#### **PROPOSAL OUTLINE**

- 1. CONDITION OF APPROVAL D: PERIMETER FENCING
- 2. CONDITION OF APPROVAL E: VIEW SHED
- 3. ROOF CANOPY MATERIAL
- 4. SOUTH VERTICAL TOWER MASSING
- 5. LEVEL 2 GLAZING / BALCONIES
- 6. SMOKE EXHAUST LOUVERS
- 7. LIGHT RAIL POLE PLACEMENT

CONDITION OF APPROVAL D - FENCING APPROVED SECURITY MESH

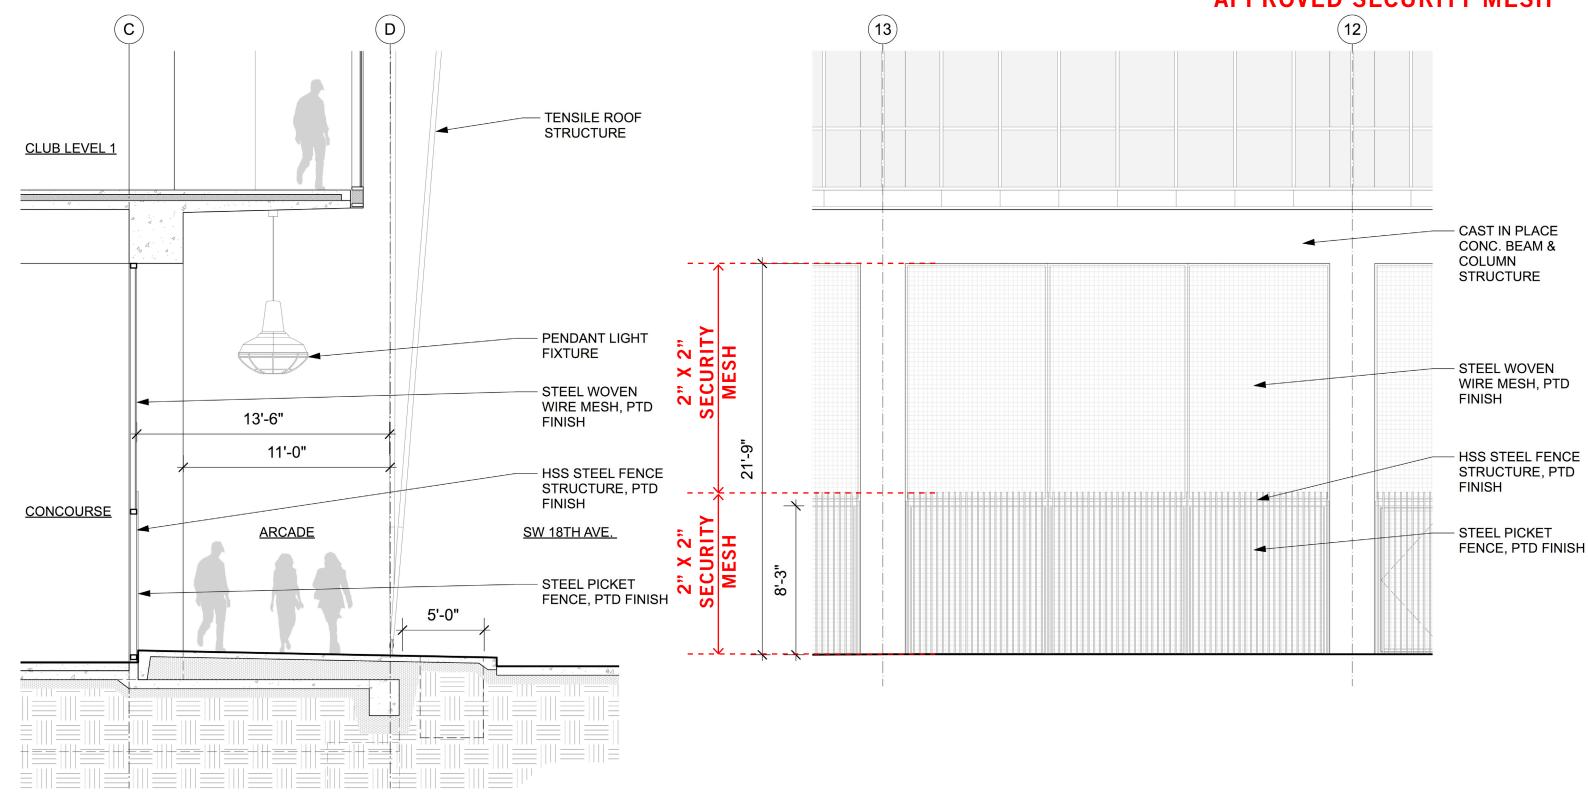
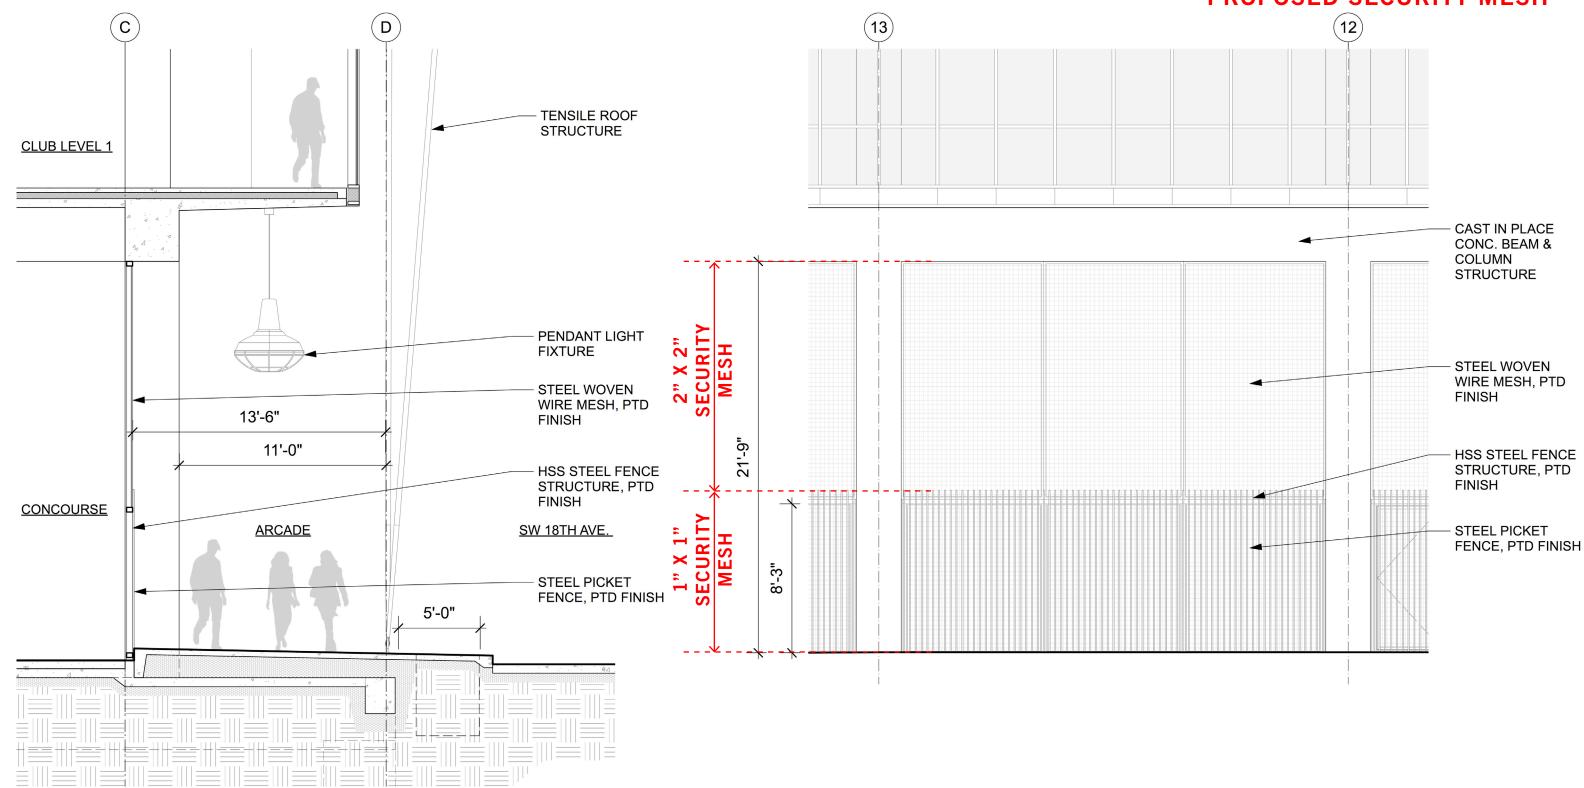
CONDITION OF APPROVAL D - FENCING PROPOSED SECURITY MESH

CONDITION OF APPROVAL E - VIEW SHED

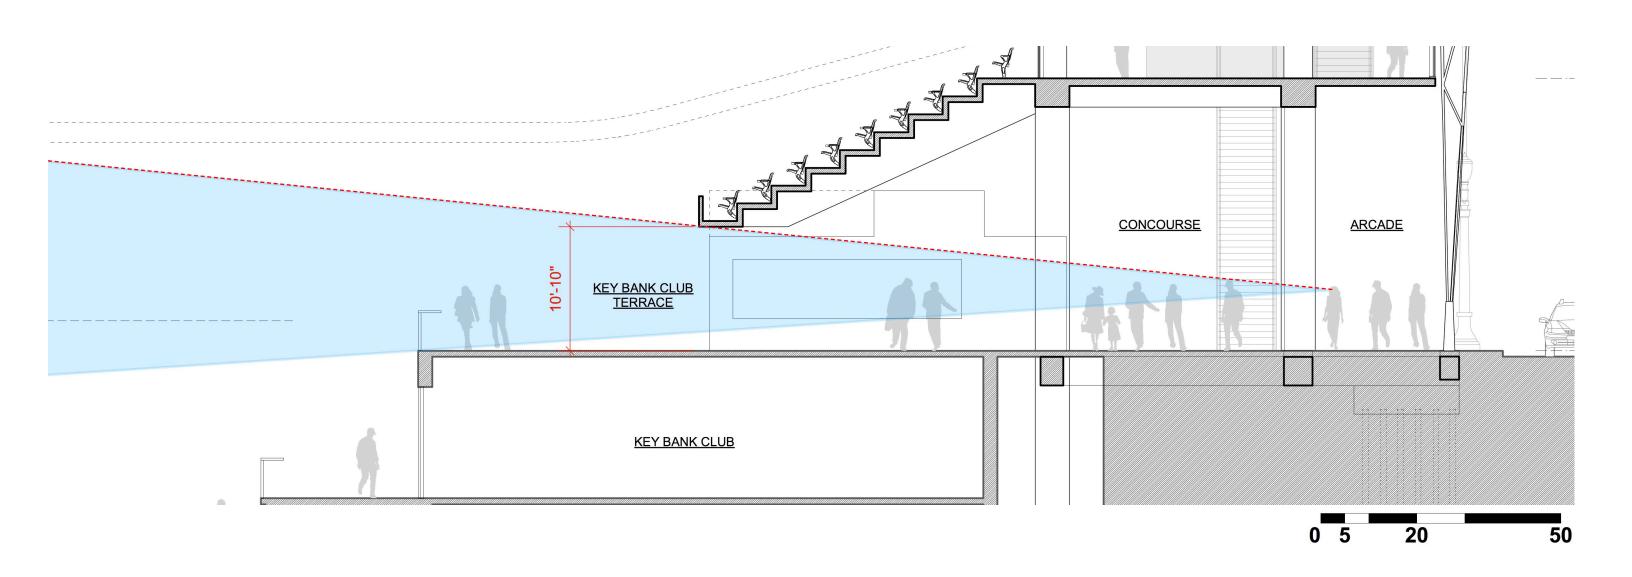
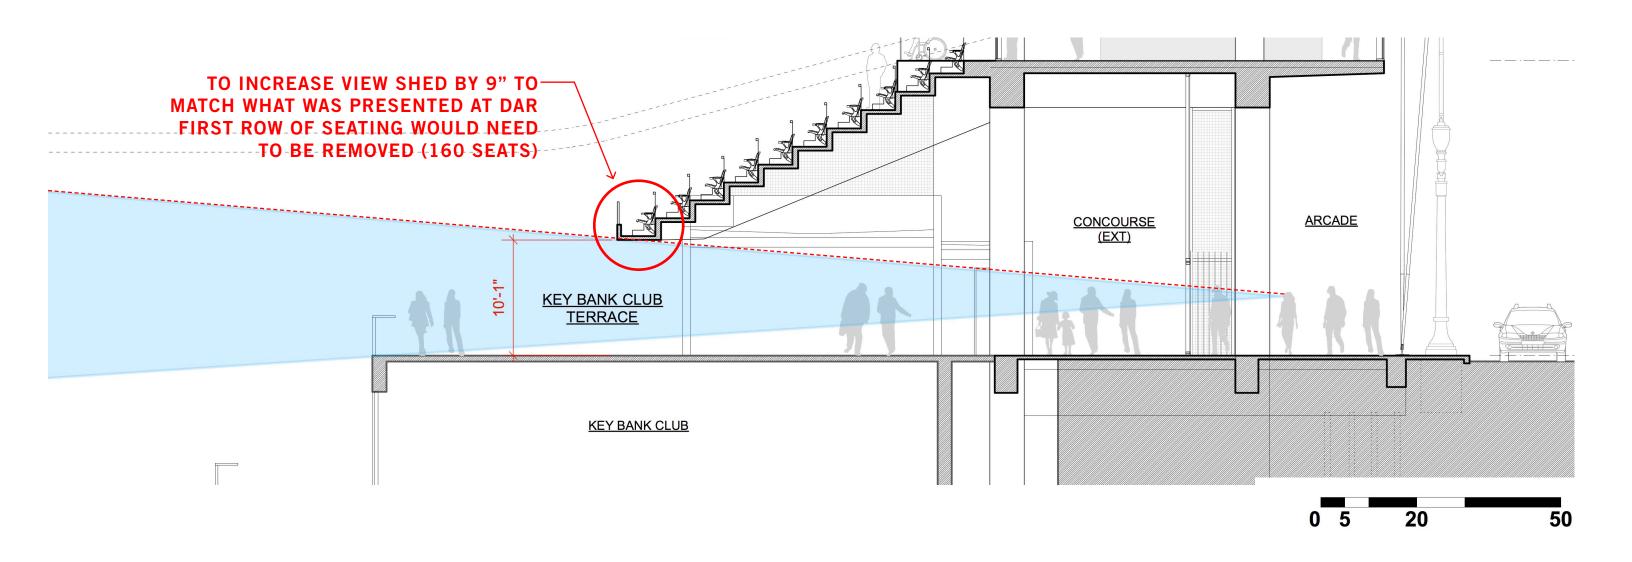
DAR SECTION FOR REFERENCE: 10'-10" VERTICAL VIEW SHED INTO STADIUM

APPROVAL CRITERIA: 11'-3" VERTICAL VIEW SHED INTO STADIUM REQUIRED

## PROPOSAL ITEM 3. REVISED ROOF CANOPY MATERIAL

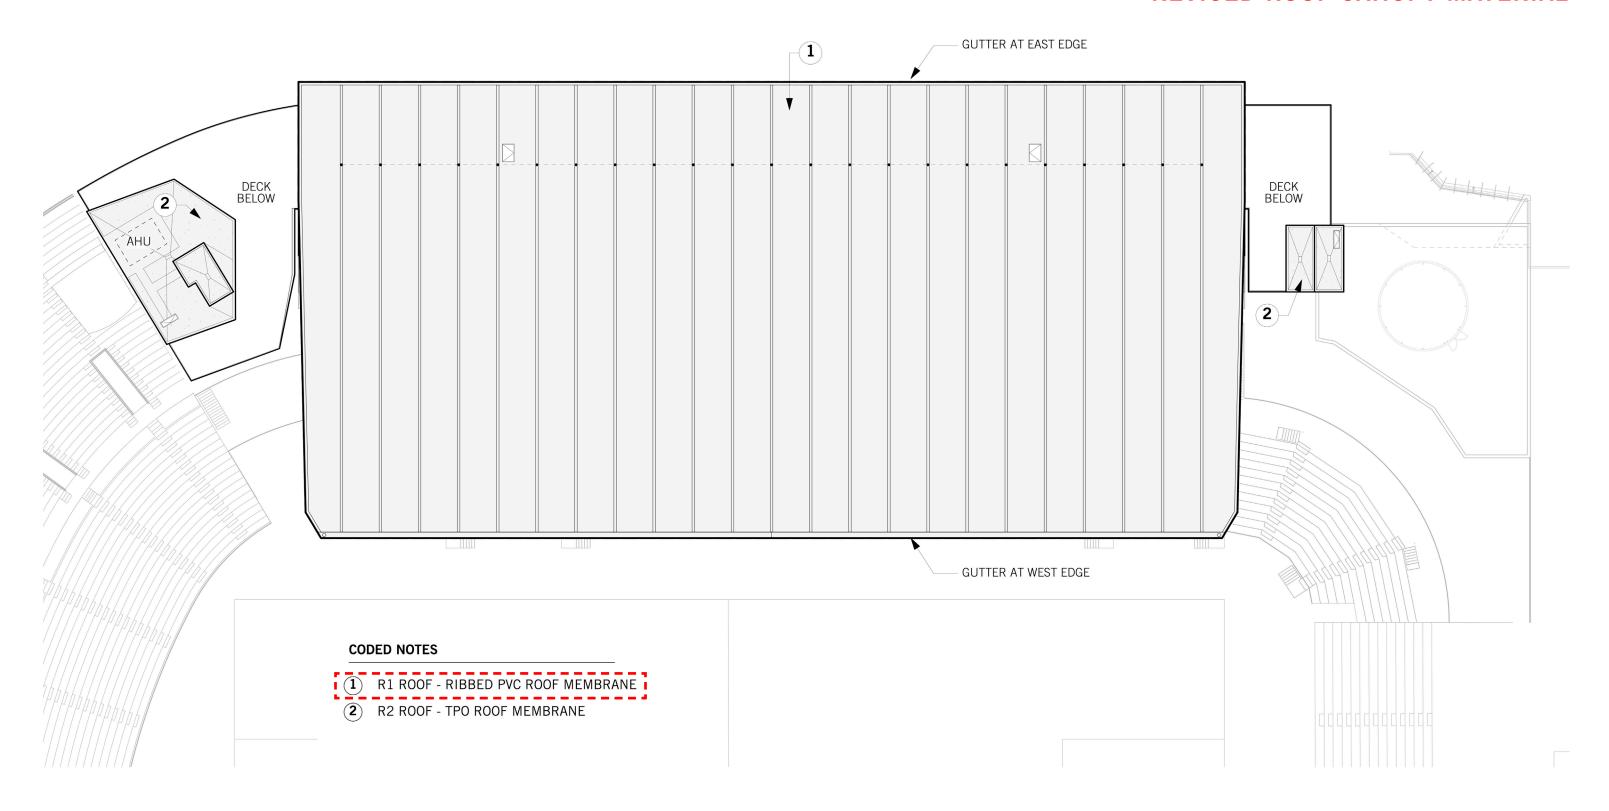
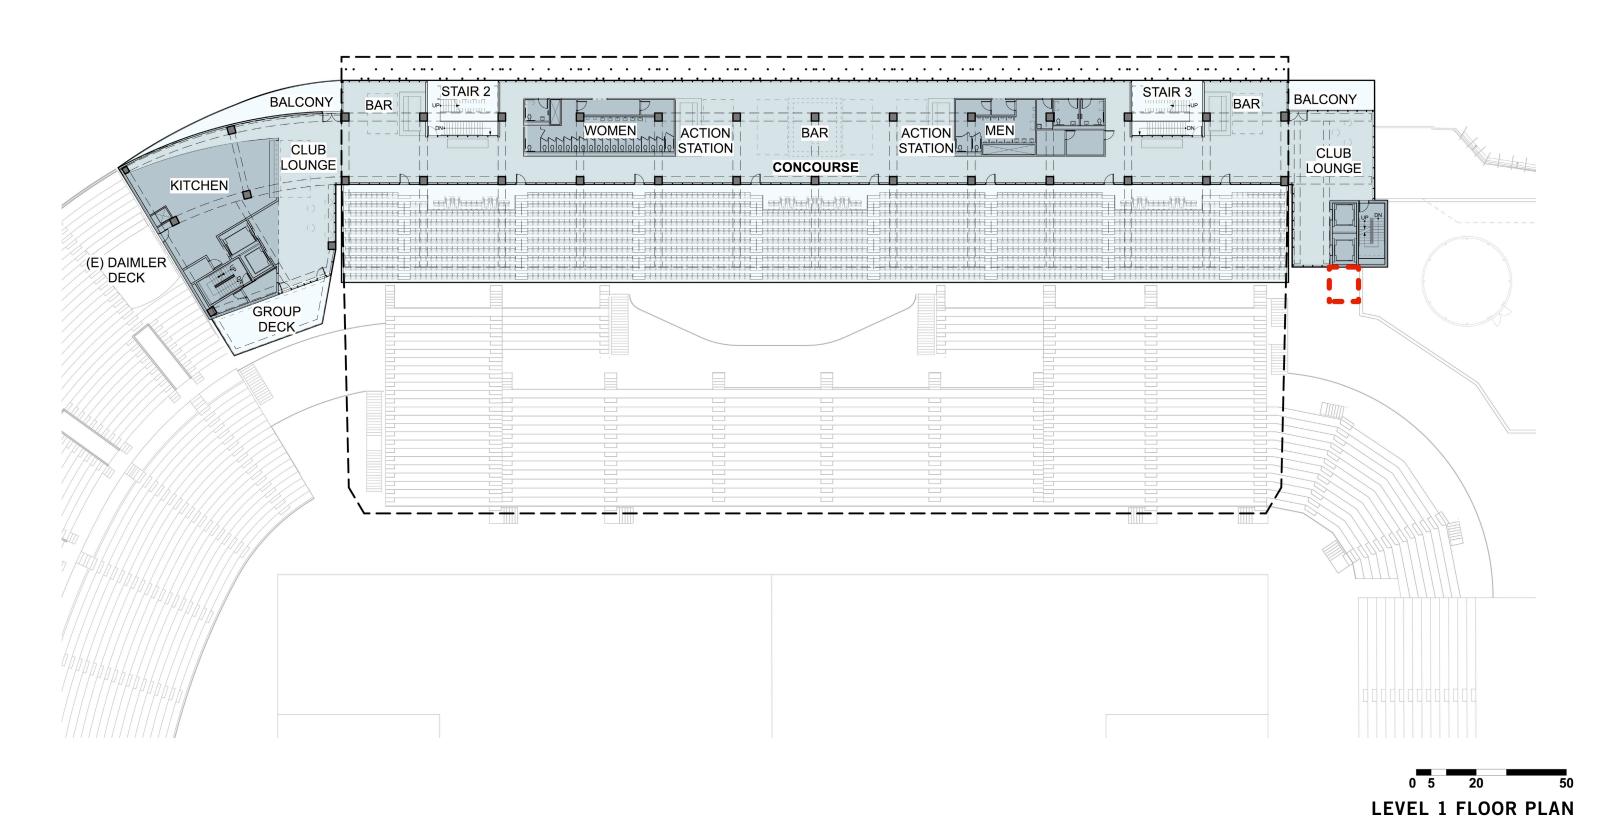
#### REVISED ROOF CANOPY MATERIAL

RIBBED PVC MEMBRANE OVER METAL DECKING W/PAINTED FINISH

# PROPOSAL ITEM 5. REDUCED GLAZING / EXPANDED L2 BALCONIES

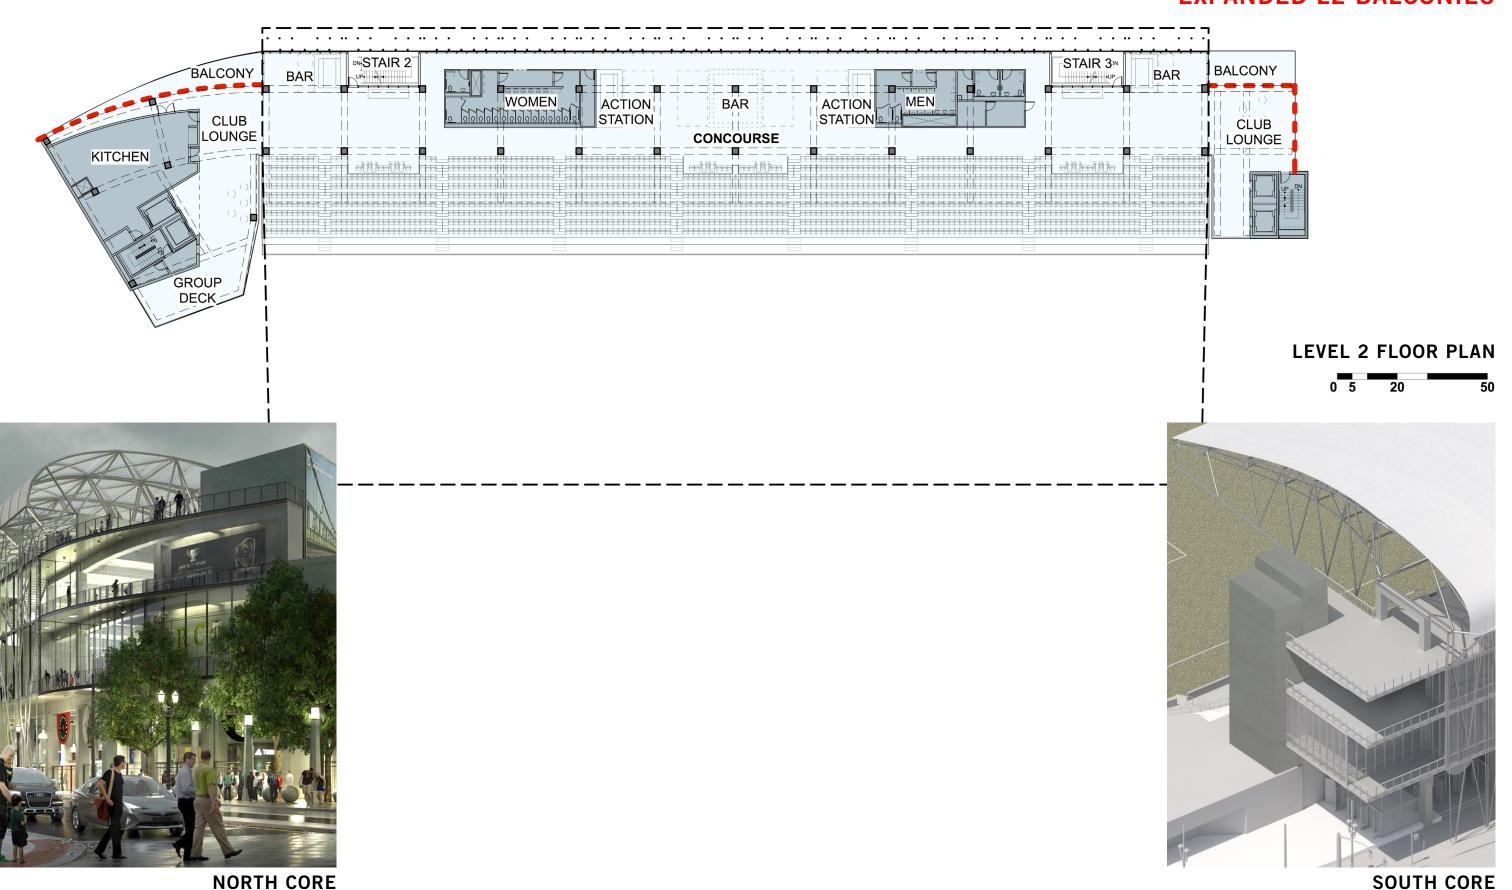
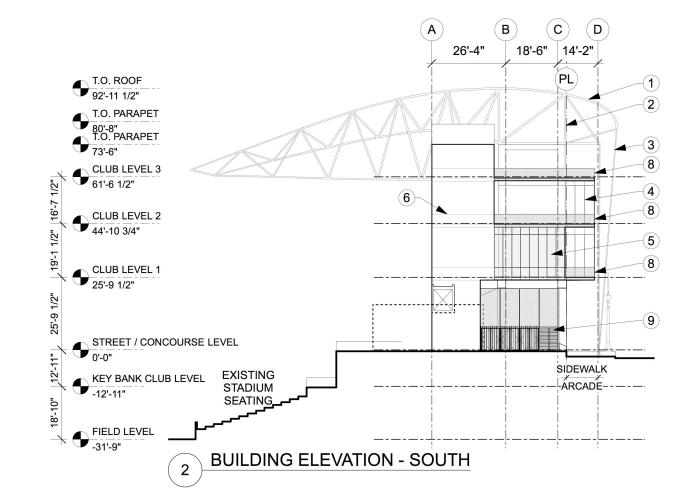
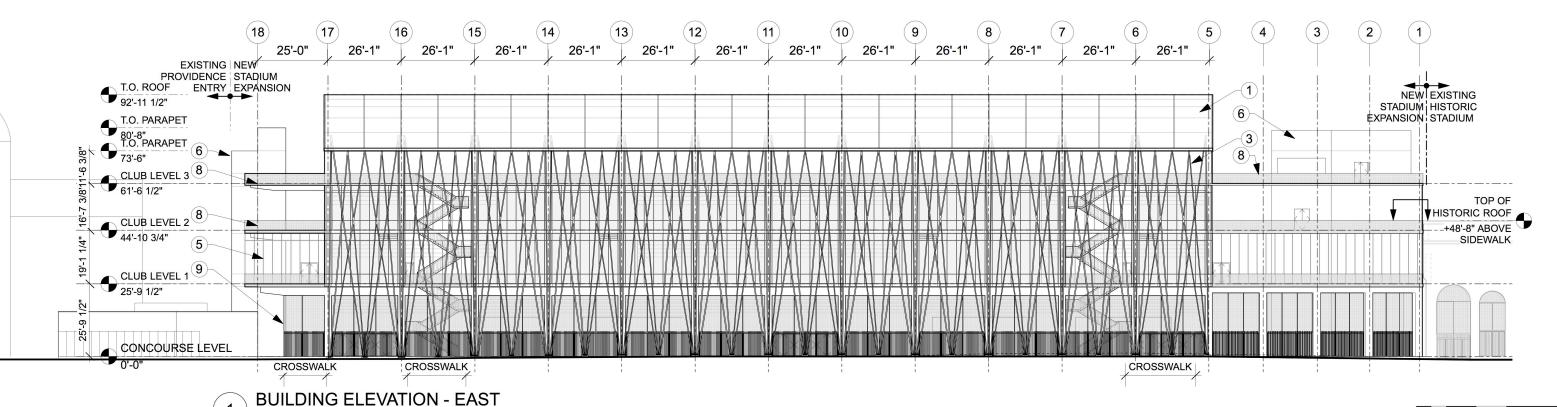
REDUCED GLAZING / EXPANDED L2 BALCONIES

SW 18TH STREET ELEVATION - STREET FURNISHINGS

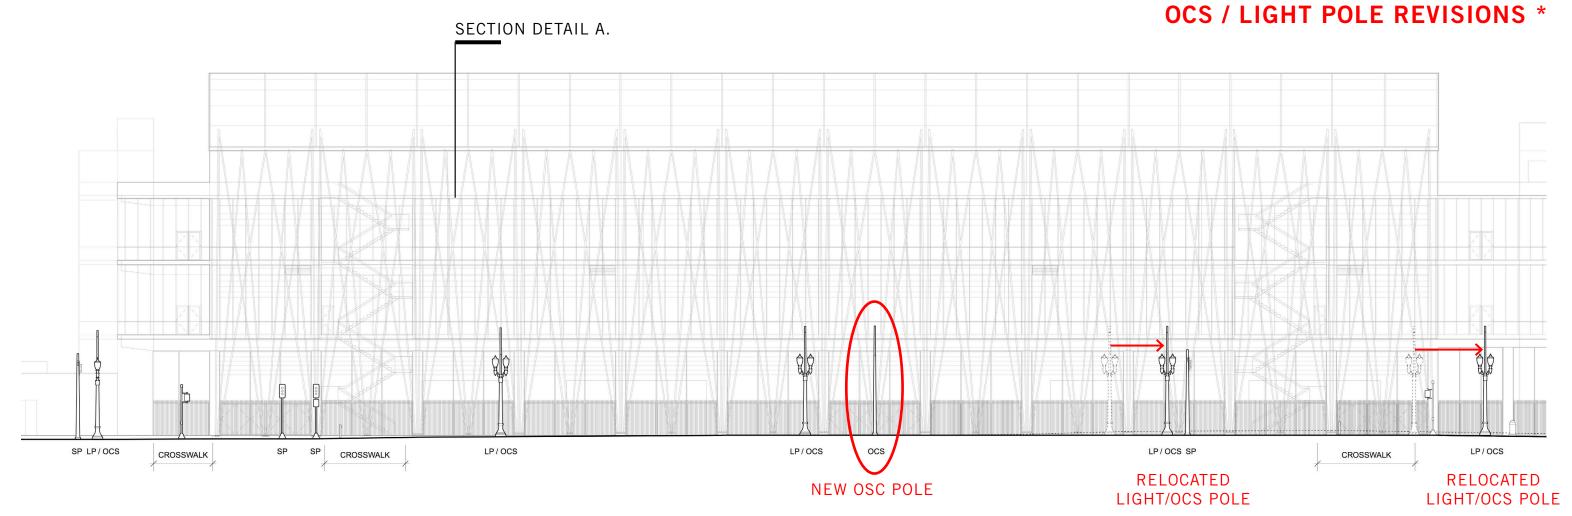
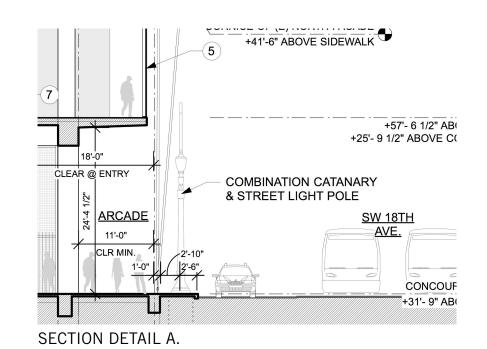
\* STREET FURNISHING AND OCS POLE REVISIONS PER PBOT REVIEW AND PUBLIC WORKS APPROVAL AND PER TRIMET REVIEW
